## **Staff Report**

| То:           | Planning Commission  |  |  |  |
|---------------|--|--|--|--|
| Meeting Date: | October 10, 2019 (Prepared October 3, 2019)  |  |  |  |
| Item:         | 440 Parr Road "Heritage Elementary School" (CU 2019-02, DR 2019-02, EXCP 2019-02, & VAR 2019-01) |  |  |  |

Figure 3.05C - Parking Space Striping

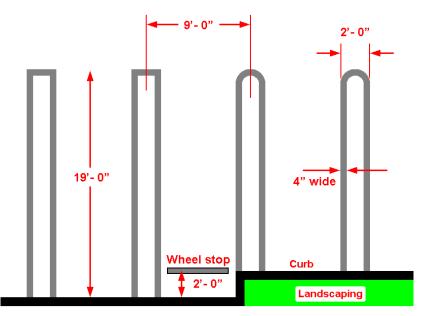
The applicant proposes all stalls, which are all at 90°, to the drive aisle with dimensions, doublestriping, and curbing that meet or exceed the minimum standards – except as regards the variance requests for parking stall length minimum and drive aisle width minimum.

D3. Parking stall double striping: To meet WDO 3.05.02K, the applicant shall delineate altered or additional off-street parking stalls with double parallel lines pursuant to Figure 3.05C.
